**TECHNICAL COMMITTEE RECOMMENDATION**

**TECHNICAL COMMITTEE:** Signals Technical Committee

**TOPIC:** **Section 4C.05 Warrant 4, Pedestrian Volume**

Page 4C-6, 2003 Edition of MUTCD, Rev. 1

**Figure 4C-5. Warrant 4, Pedestrian Four-Hour Volume**

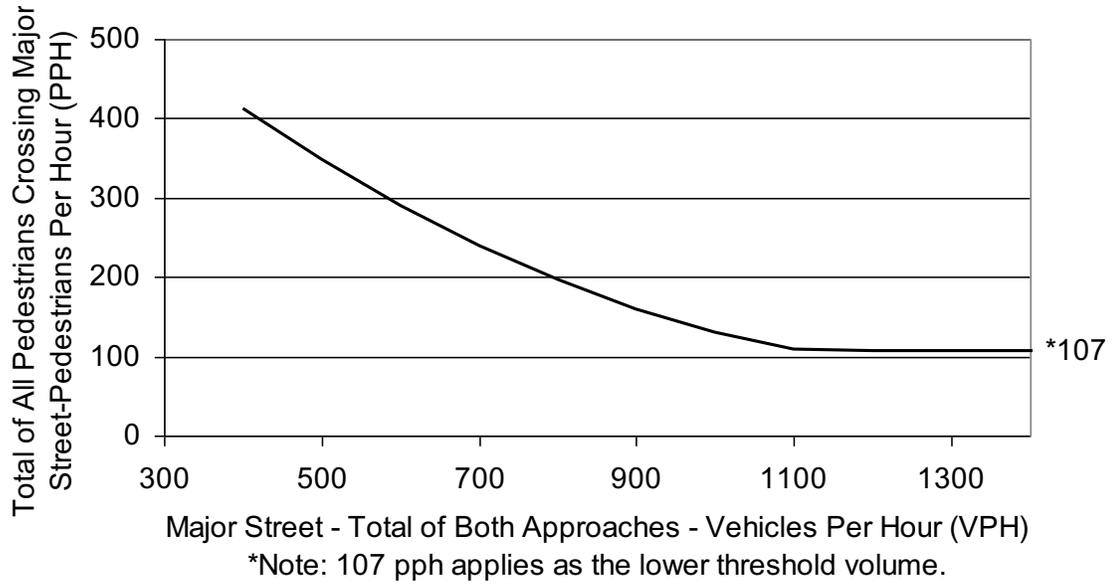
- A. For each of any 4 hours of an average day, the plotted points representing the vehicles per hour on the major street (total of both approaches) and the corresponding pedestrians per hour crossing the major street (total of all crossings) all fall above the curve in Figure 4C-5; or
- B. For 1 hour (any four consecutive 15-minute periods) of an average day, the plotted point representing the vehicles per hour on the major street (total of both approaches) and the corresponding pedestrians per hour crossing the major street (total of all crossings) falls above the curve in Figure 4C-6.

**Figure 4C-7. Warrant 4, Pedestrian Four-Hour Volume (70% Factor)**

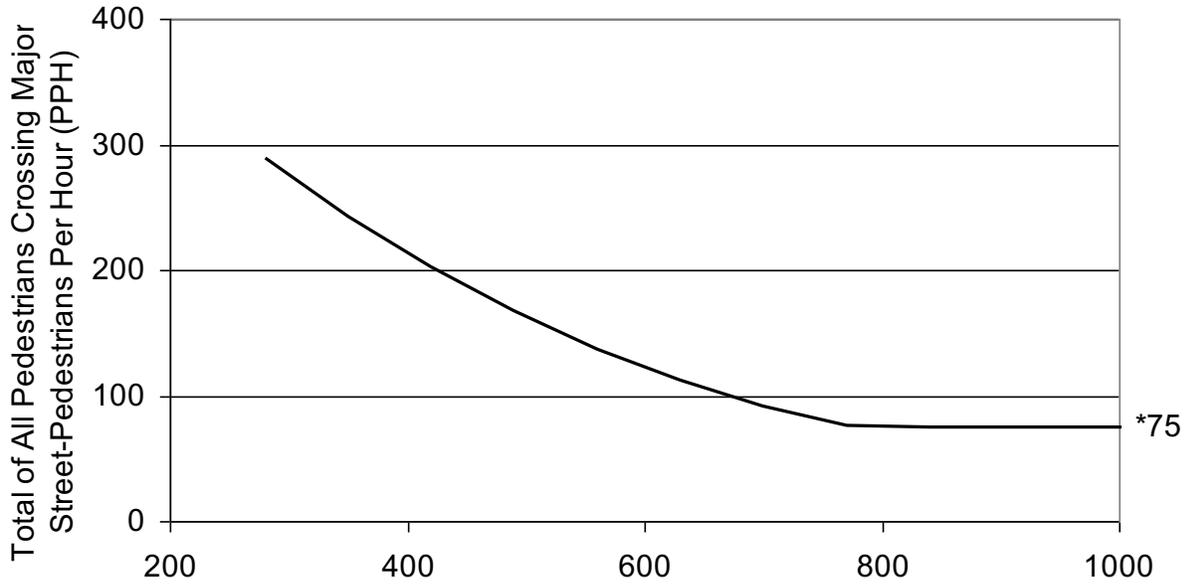
If the posted or statutory speed limit or the 85th-percentile speed on the major street exceeds 60 km/h or exceeds 35 mph, or if the intersection lies within the built-up area of an isolated community having a population of less than 10,000, Figure 4C-7 may be used in place of Figure 4C-5 to satisfy Criterion A in the Standard above, and Figure 4C-8 may be used in place of Figure 4C-6 to satisfy Criterion B in the Standard above.
